January 26, 2018

Re: *Northwest Natural Gas Company (LNG Plant)*
ODEQ File No. 62231
Application for new NPDES permit

Exxon Mobil Corporation ("ExxonMobil") appreciates the opportunity to submit comments on the application for a new NPDES permit submitted by Northwest Natural Gas Company for riverfront property located 6900 St. Helens Road, Portland, Oregon ("the Gasco Site") on December 20, 2017. We understand that NW Natural is seeking to be covered by the general permit for storm water, dated August 2017.

**Figure 2-1
Site Plan**

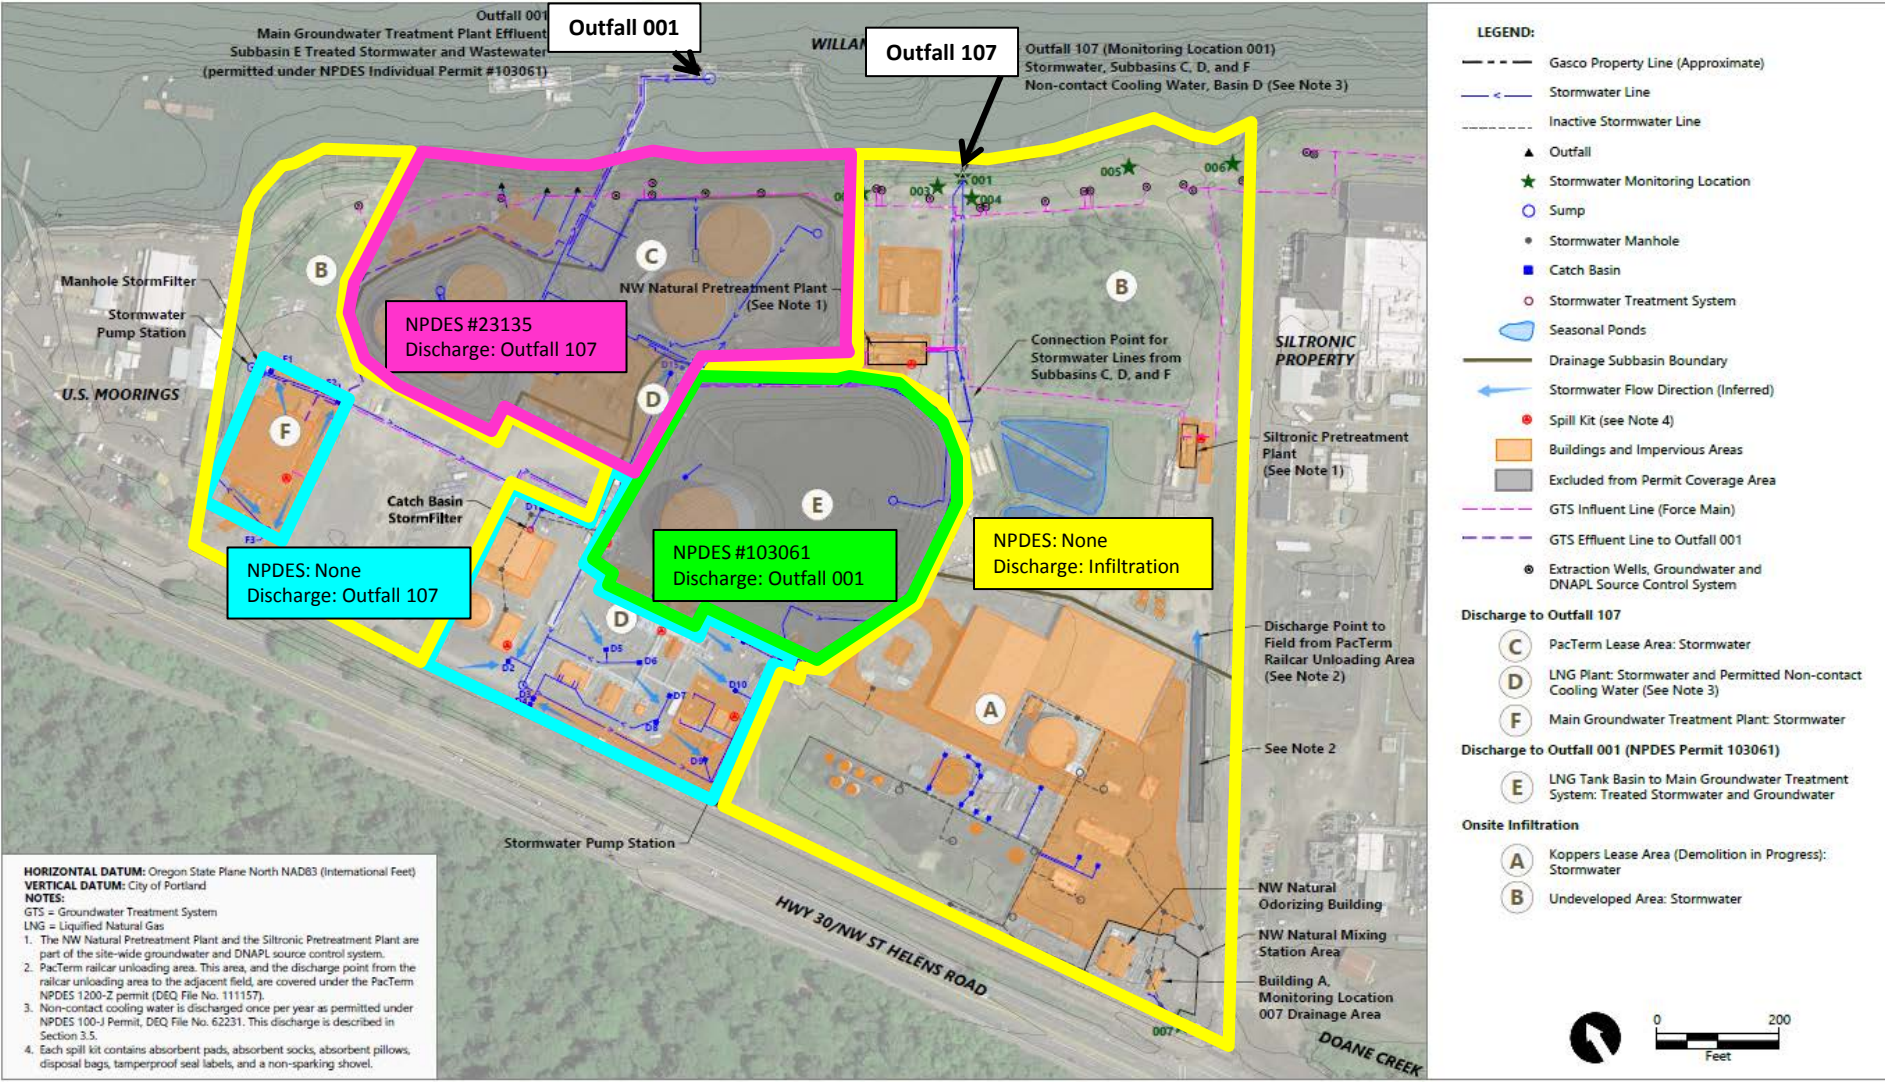
We understand that there are two active outfalls at the Gasco Site. (See Anchor site plan attached as Exhibit A.) A portion of the discharge from the Site reaches the Willamette River through Outfall 001 including the effluent from the on-site groundwater treatment plant discharge. The Outfall 001 discharge has an existing permit. However, the portion of the Gasco Site that discharges to Outfall 107 has apparently never had an NPDES permit, despite the fact that significant contamination has long been known to be discharged from this outfall. For example, during the remedial investigation conducted by the Lower Willamette Group, the outfall in question – 107 – was sampled on multiple occasions in 2007-08 and again in 2009-10. All the results showed that the concentrations of PAH in stormwater solids being discharged at Outfall 107 were elevated and significantly exceeded the sediment cleanup standards later identified in the Record of Decision for the Portland Harbor Site.¹
